GRACE VALLEY RANCH, PHASE 6

ADDENDUM #2

05/16/2025

C4.07

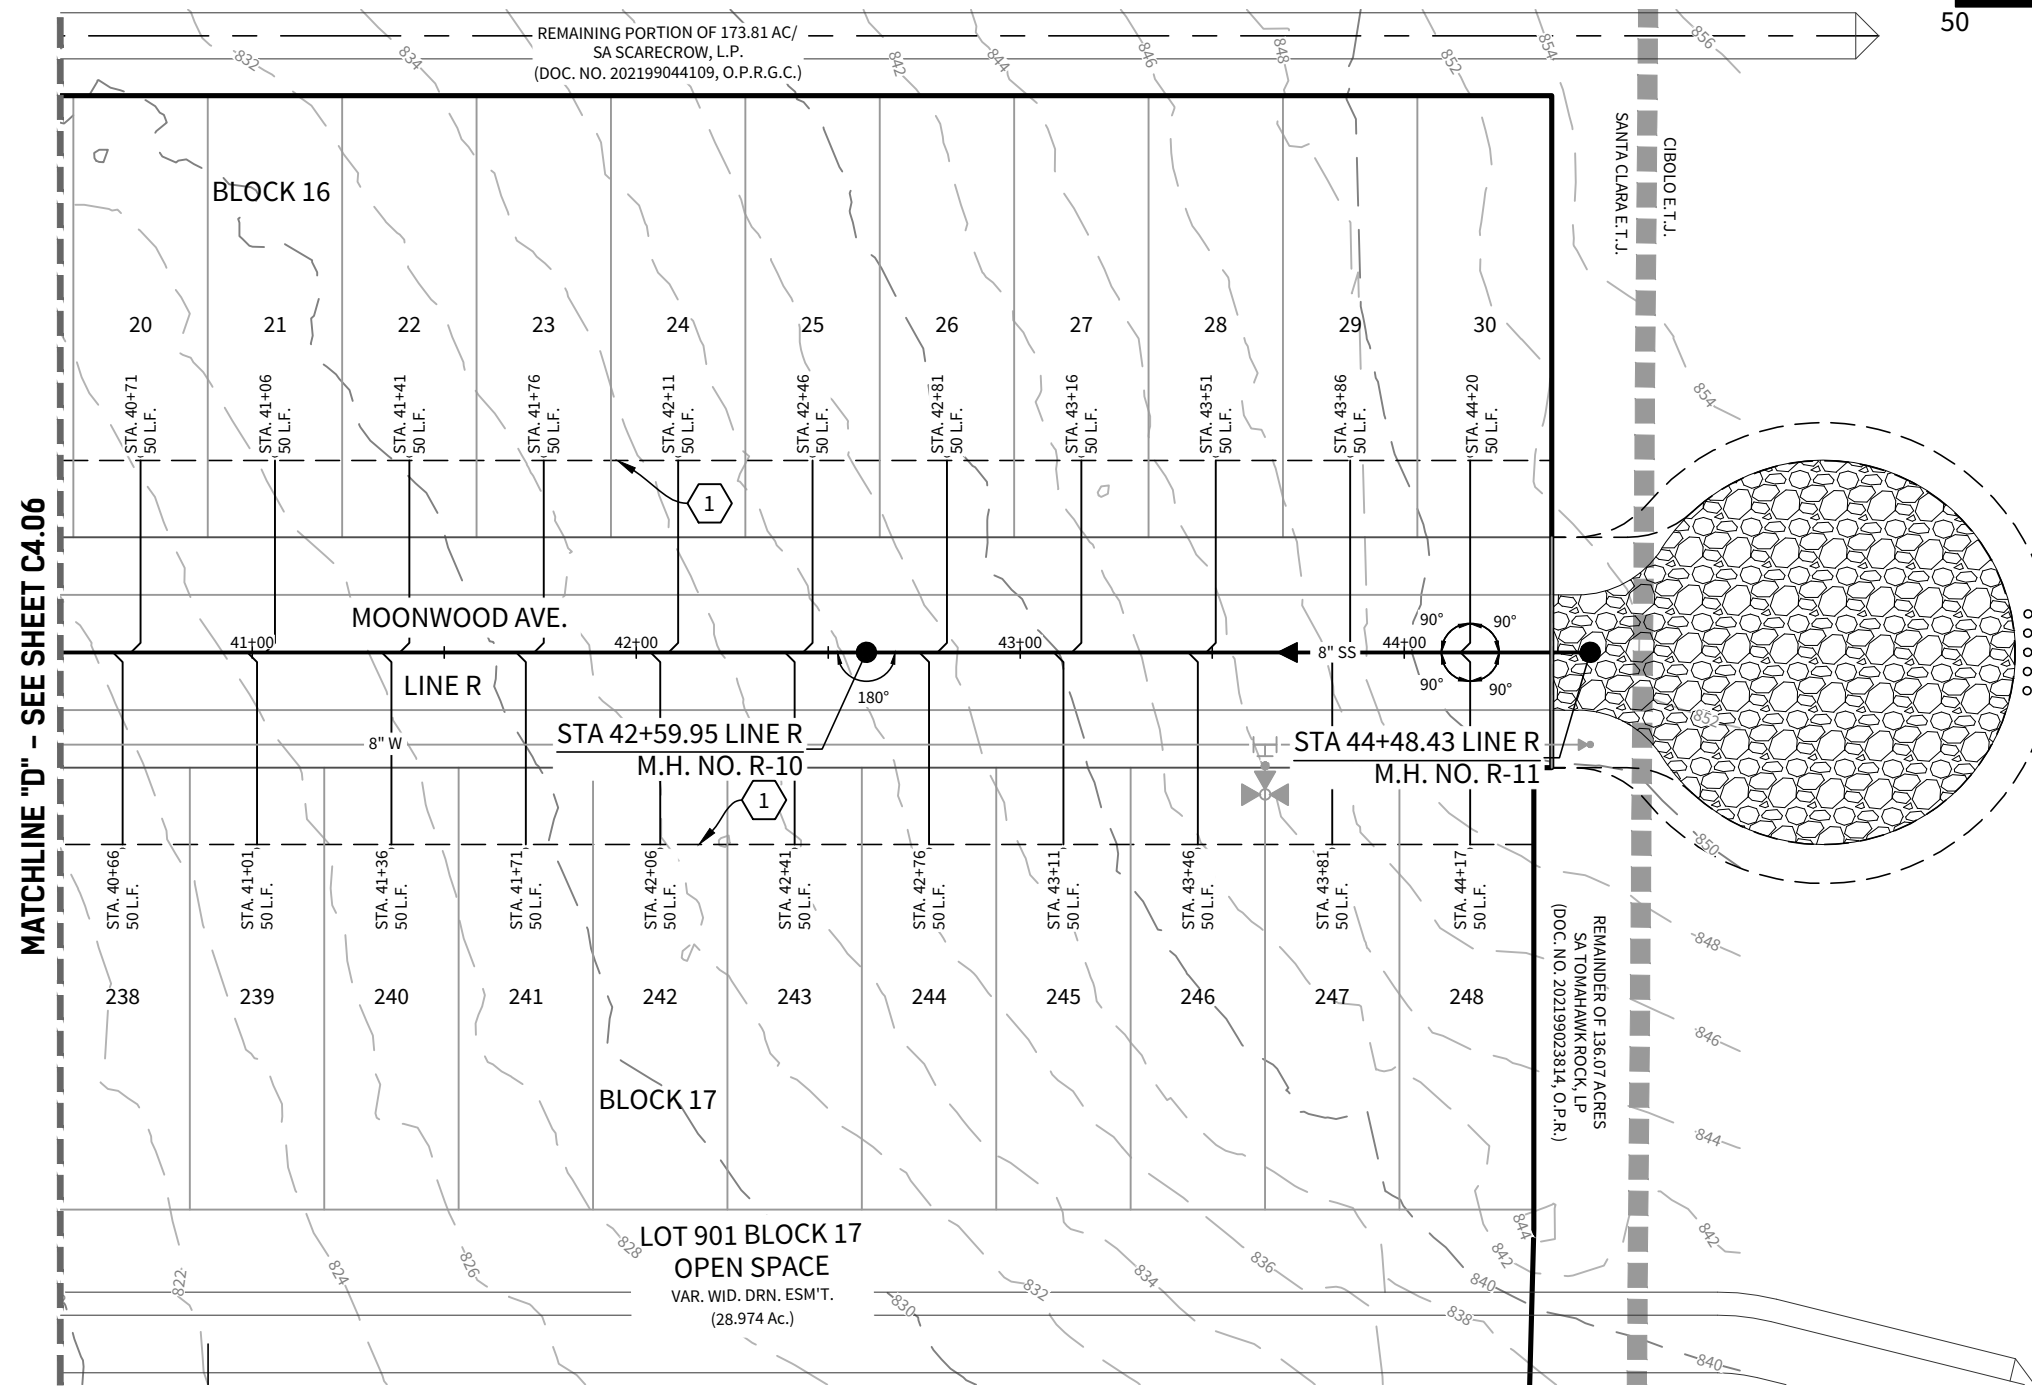
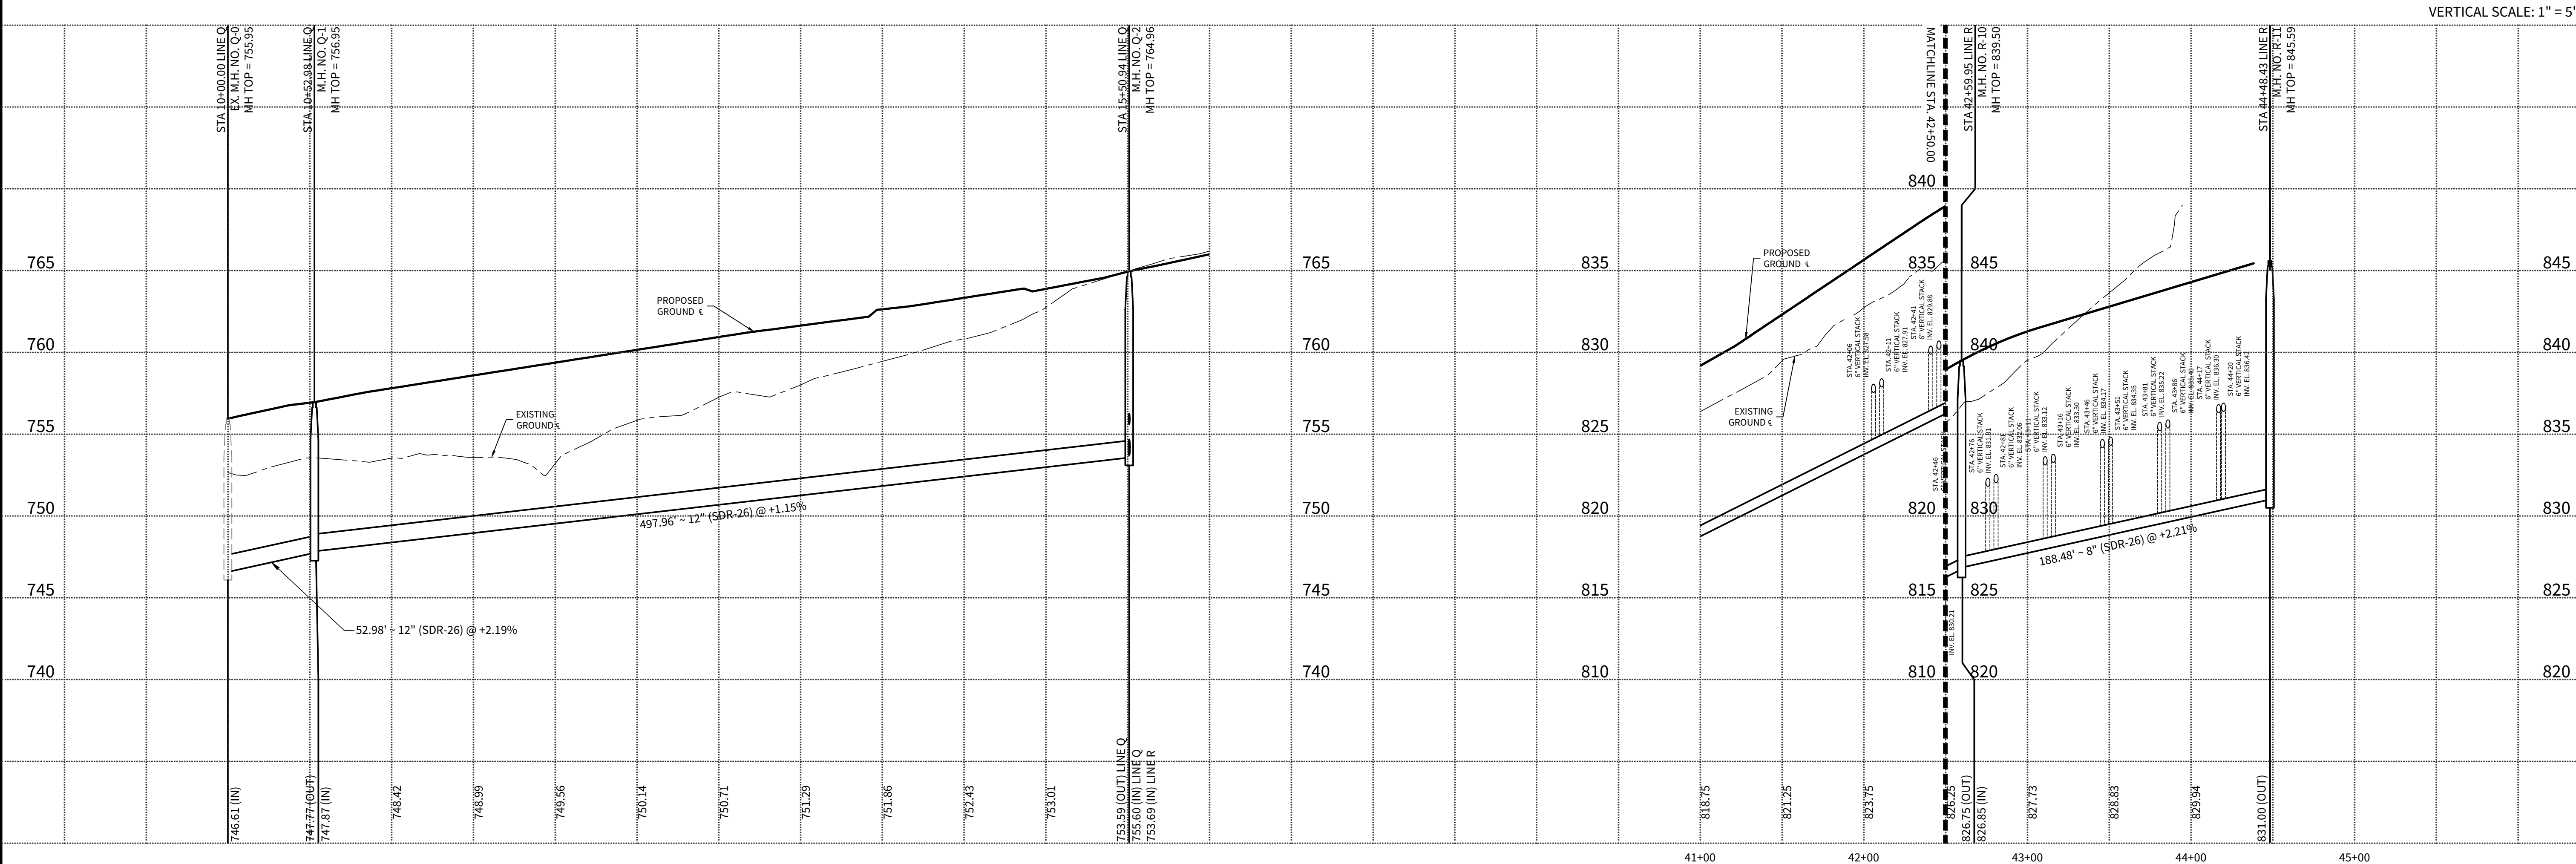
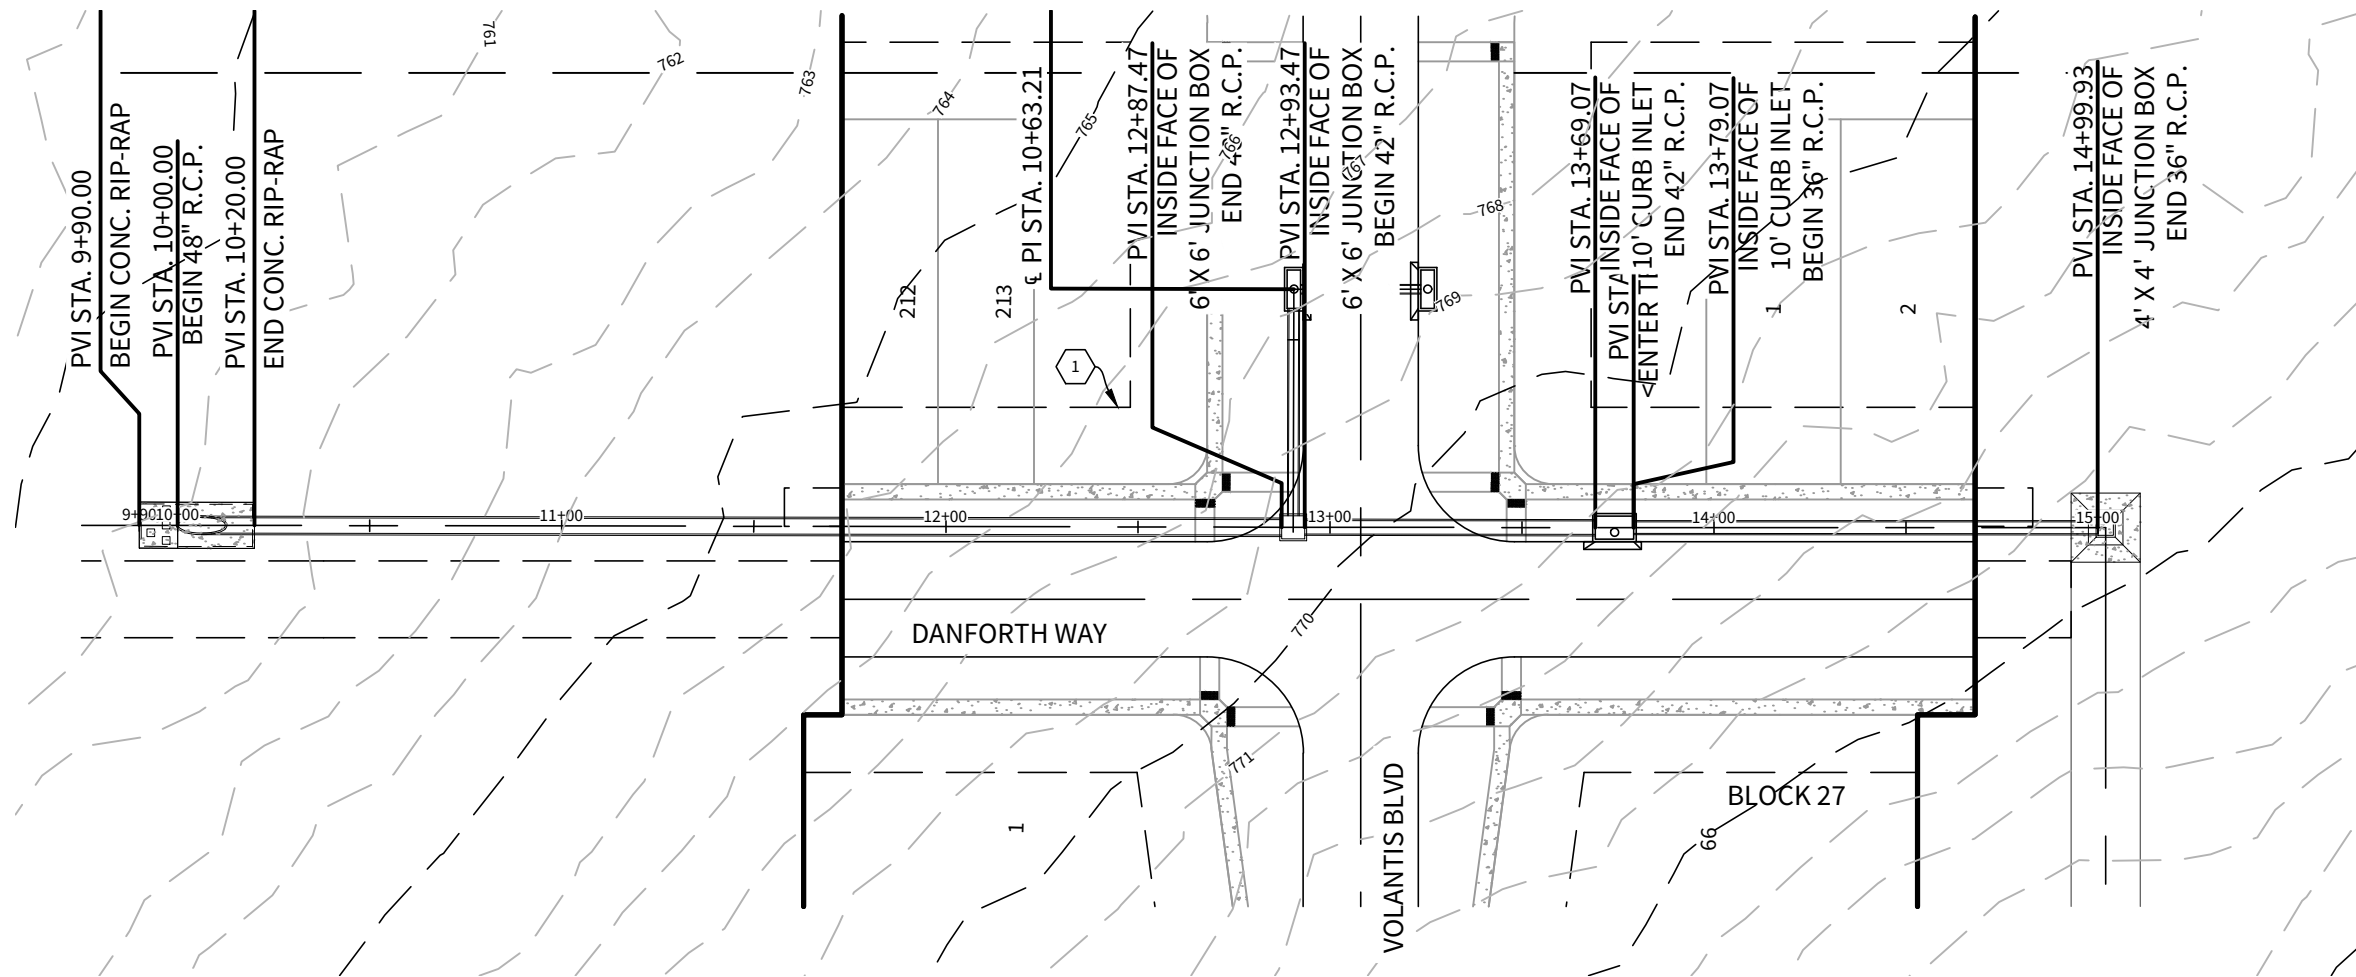
- Question 33** Bid tab calls for 10649 LF of 6" sewer lateral. Plans call for 10855 LF..
- Answer 33** *The Bid Form has been revised to correct the amount of 6" sewer laterals to 10,523 LF. Sheets C4.03-C4.07 have been revised showing correct lateral lengths. All corrections are included in Addendum #2.*
-

- Question 34** Bid tab calls for 162 VF of Vertical Stacks. Plans call for 182 VF.
- Answer 34** *The Bid Form has been revised to correct the amount of Vertical Stacks 213 VF. Sheet C4.07 has been revised showing additional vertical stacks. All corrections are included in Addendum #2.*
-
